SERVICE BULLETIN

Reference number:	SB-01-1103	Issued: 17 December, 2018
Subject:	Modification of Headlamp Mounting Panel	
Model(s):	Vantage 19MY	
VIN Range:	All Vantage to N01296	
Applicable to:	All Dealers	
Distribute to:	After Sales Manager Executive Manager Service Manager Sales Manager	Warranty Staff Technician(s) Parts Staff Bodyshop Manager

There is a new design for the headlamp mounting panel and the front wing panel on Vantage (19MY onwards). This design changes the hole that connects the headlamp mounting panel to the front wing panel. The new panels are not compatible with the panels initially installed on vehicles up to chassis number N01296.

Figure 1

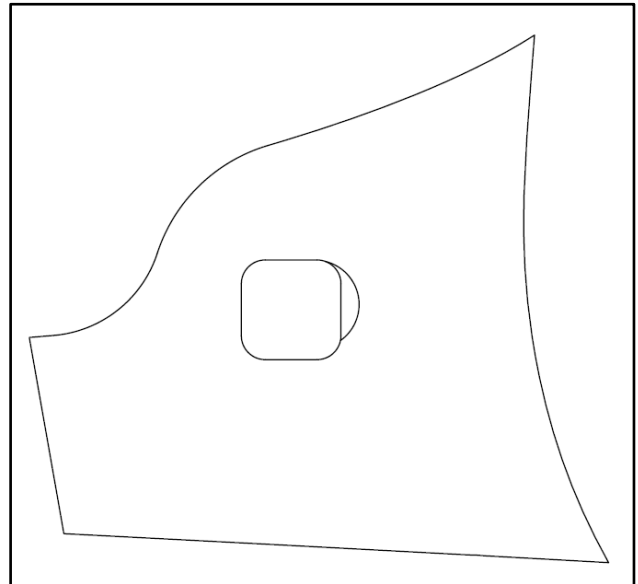
3. Cut out the template for the headlamp mounting panel. Figure 1 shows the right-side template.

Figure 2

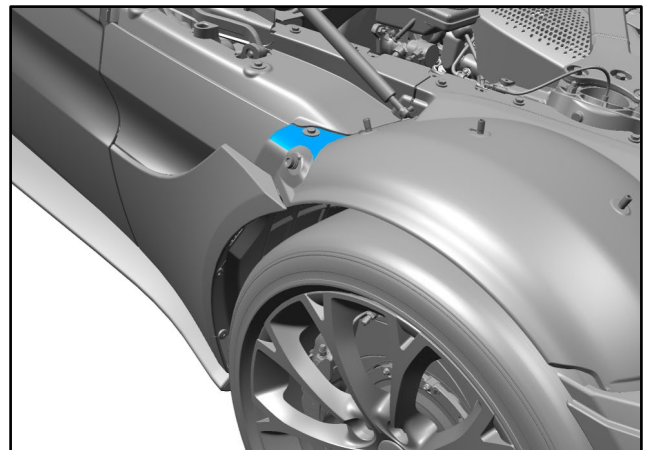
4. Use adhesive tape to attach the template to the headlamp mounting panel in the position shown (refer to Figure 2 and Figure 3).

5. Use a drill to make the new hole shape in the new headlamp mounting panel.
6. Install the new headlamp mounting panel (refer to Workshop Manual procedure 01.02.RA or 01.02.RB).

**Figure 5**

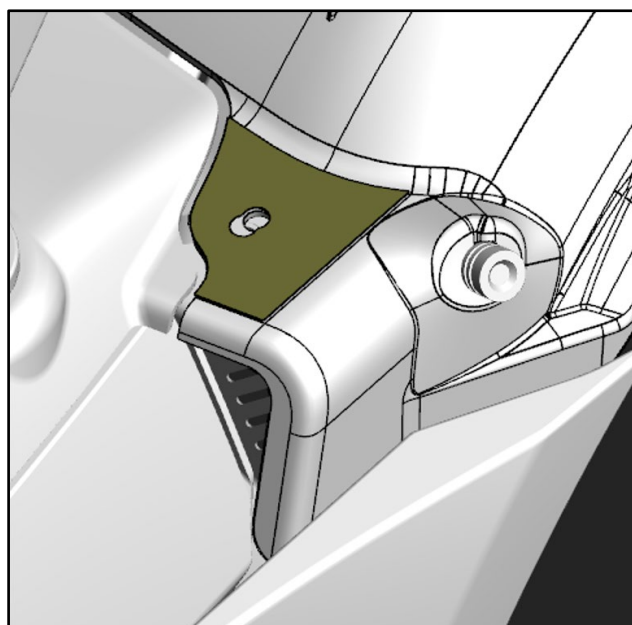
4. Use adhesive tape to attach the template to the headlamp mounting panel in the position shown (refer to Figure 5).

5. Use a drill to make the new hole shape in the headlamp mounting panel.
6. Install the new front wing panel (refer to Workshop Manual procedure 01.02.LB or 01.02.KB).

APPENDIX A
SB-01-1103 VANTAGE WING REPAIR
SCALE 1:1

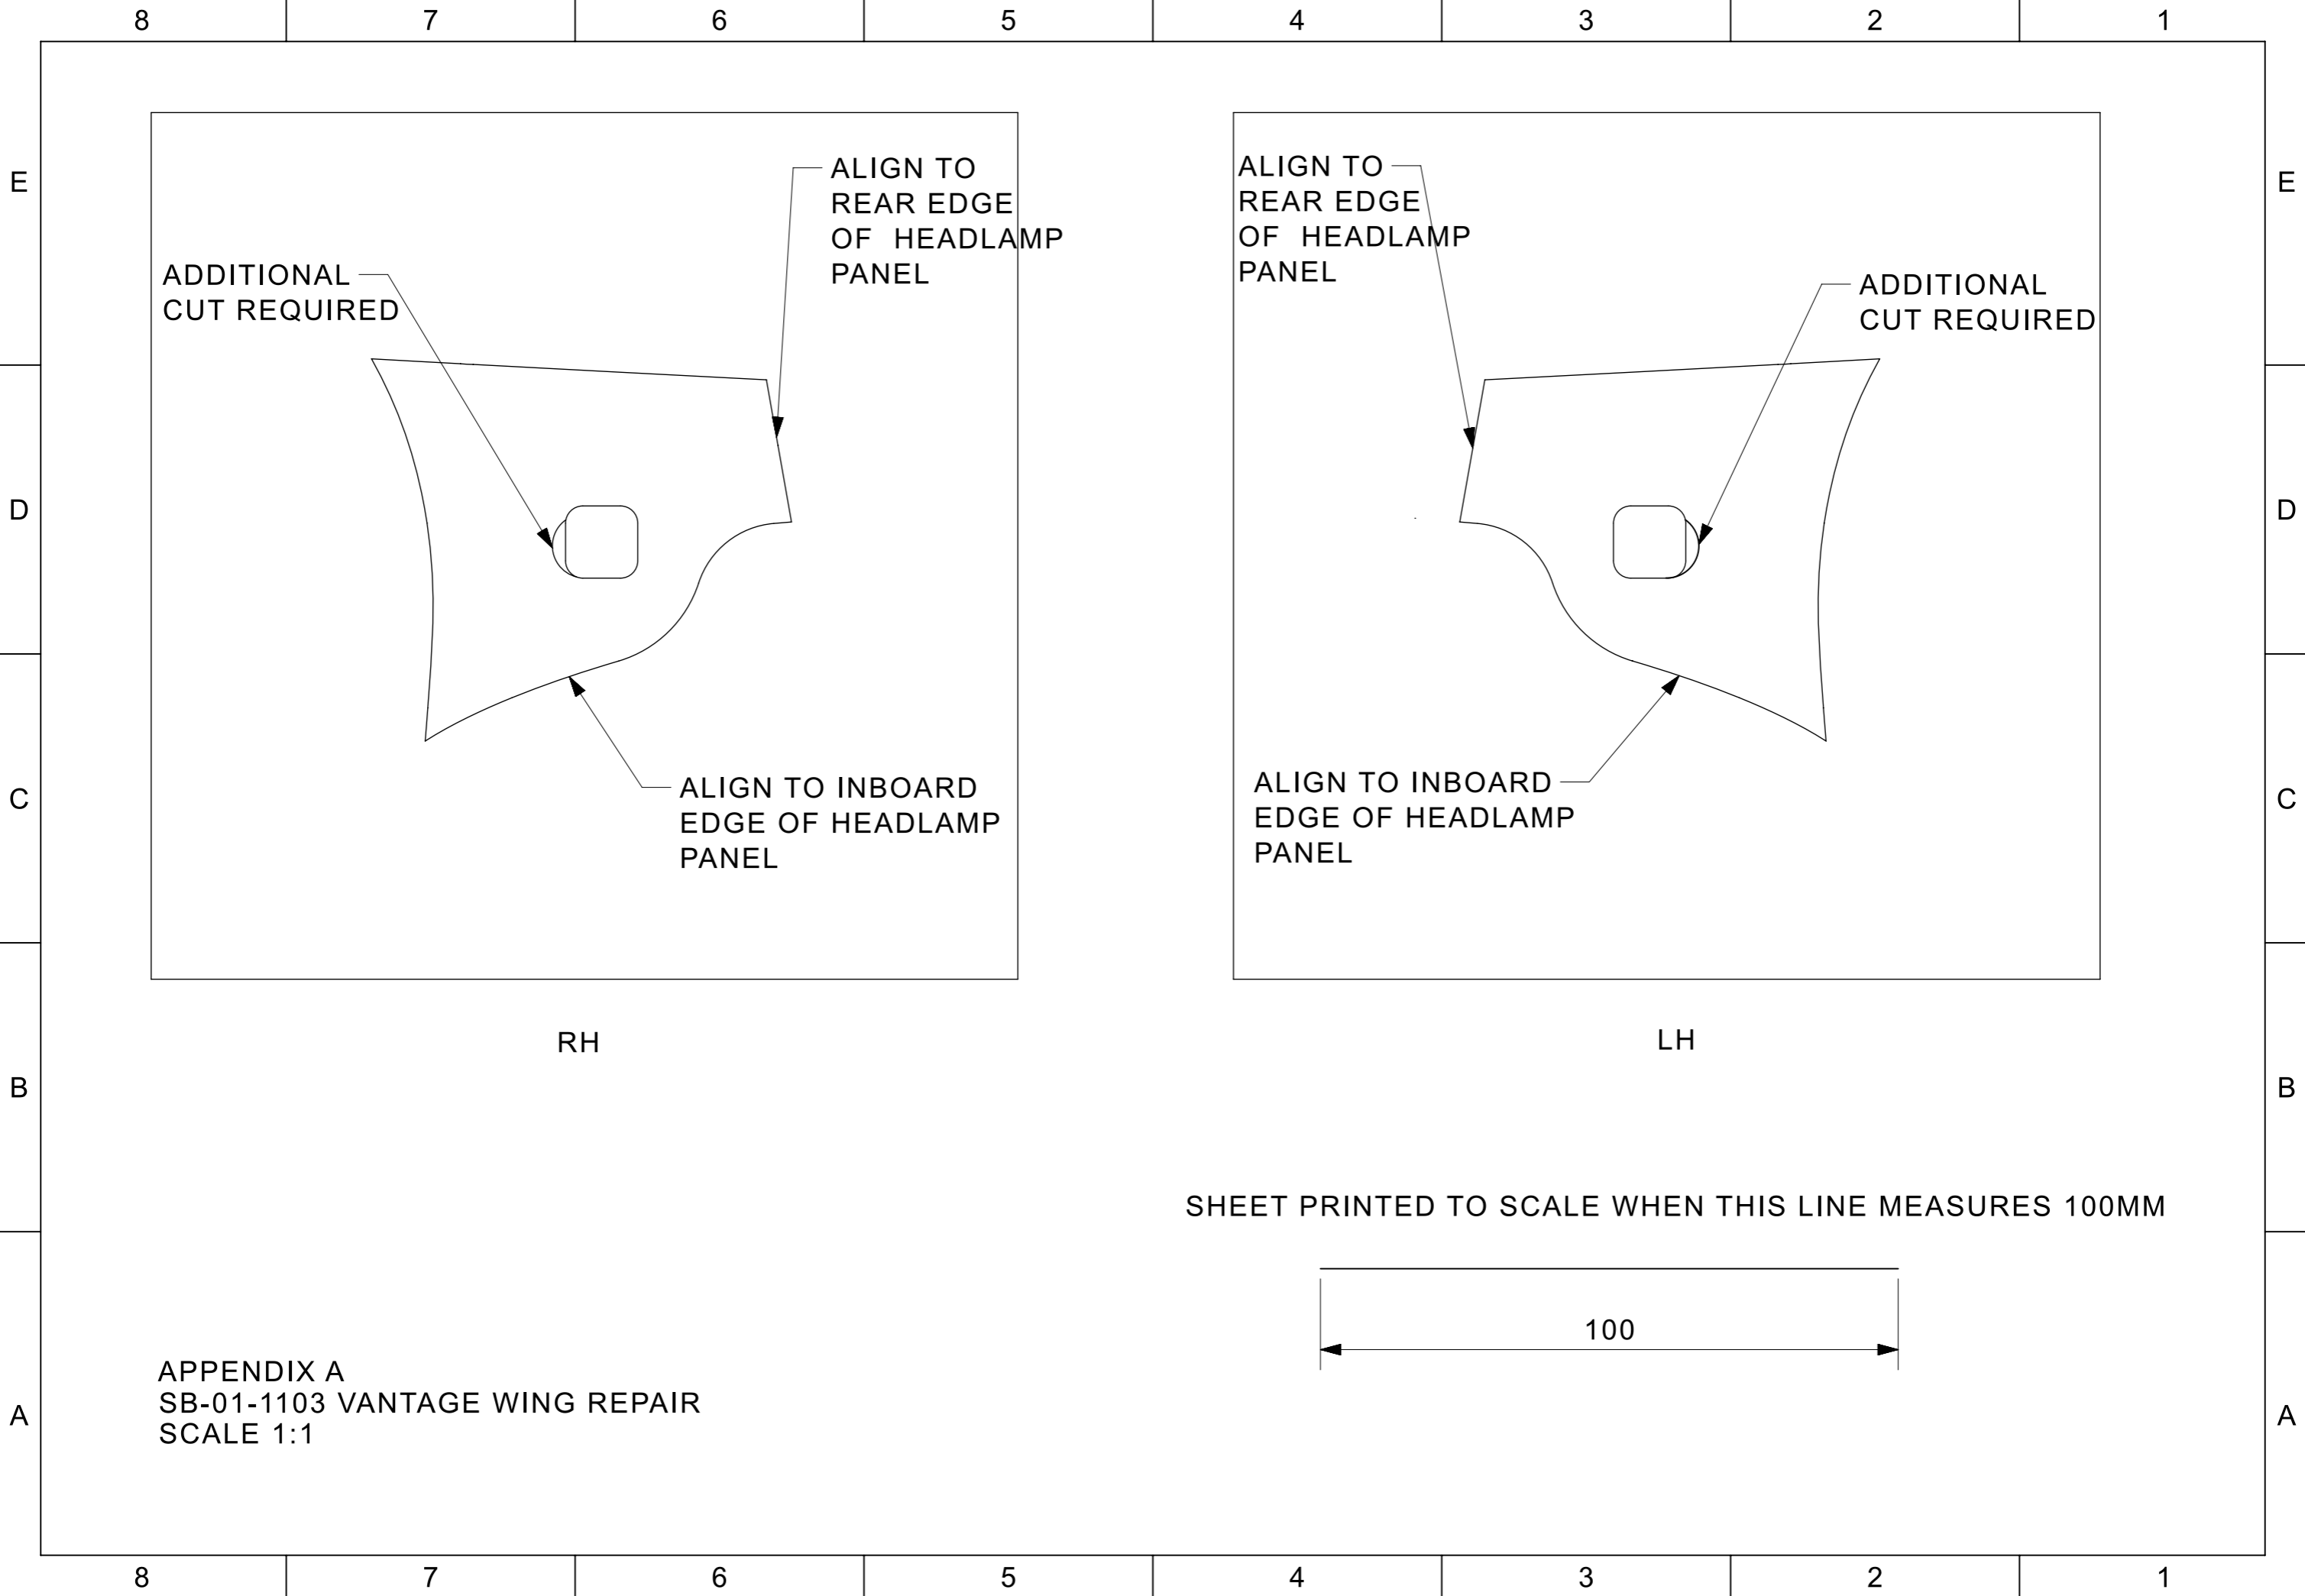
ADDITIONAL CUT REQUIRED

ALIGN TO REAR EDGE OF HEADLAMP PANEL

ALIGN TO INBOARD EDGE OF HEADLAMP PANEL

APPENDIX B
SB-01-1103 VANTAGE WING REPAIR
SCALE 1:1

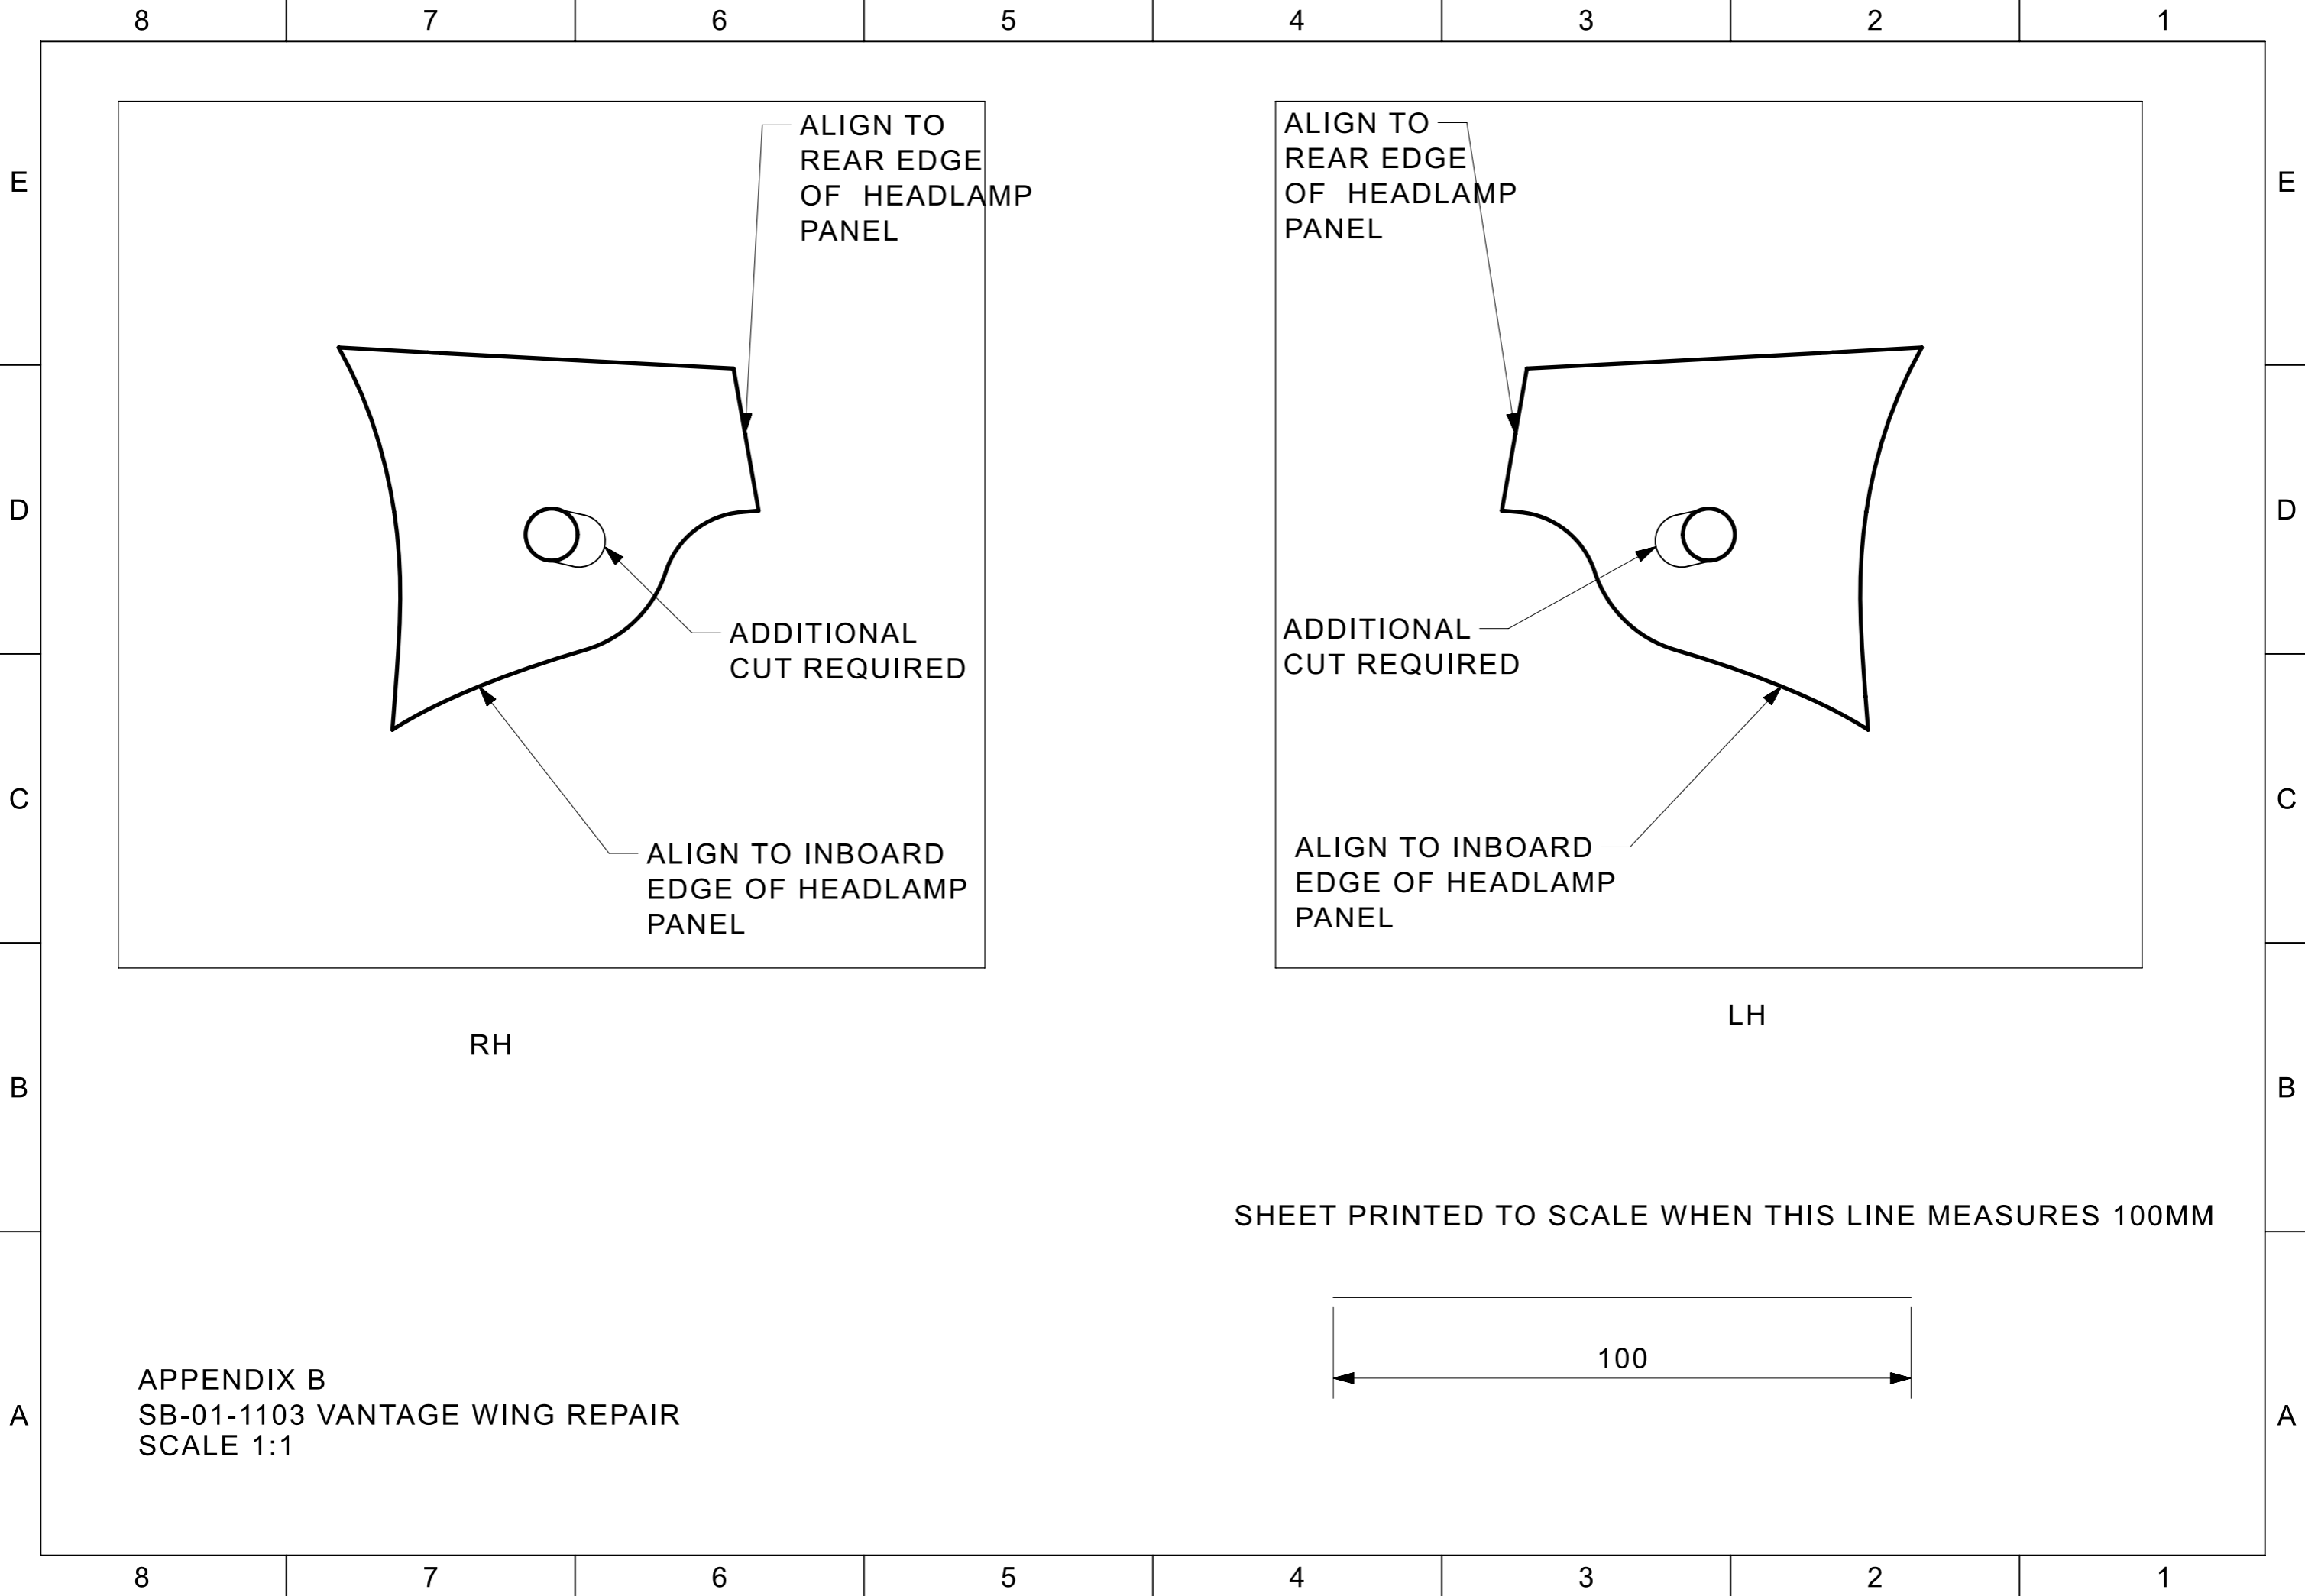
ALIGN TO
REAR EDGE
OF HEADLAMP
PANEL

ADDITIONAL
CUT REQUIRED

ALIGN TO INBOARD
EDGE OF HEADLAMP
PANEL
